Certificate of Appropriateness

102 E Vine

Date issued

6/7/2022

HORIZONTAL VENTING GAS TERMINATION CAP

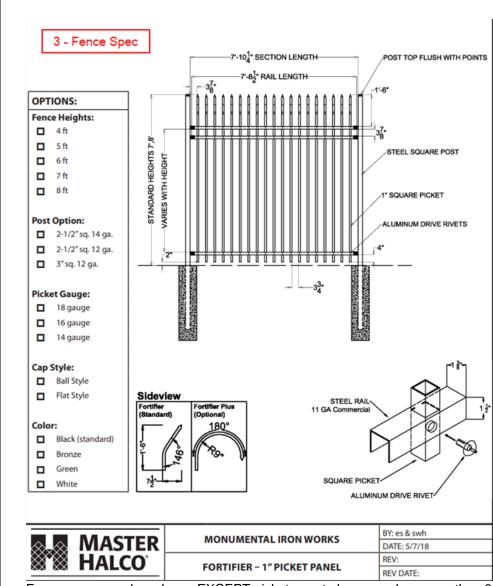
Approved cap - to be painted to match red brick

Paint termination cap to match red brick wall.
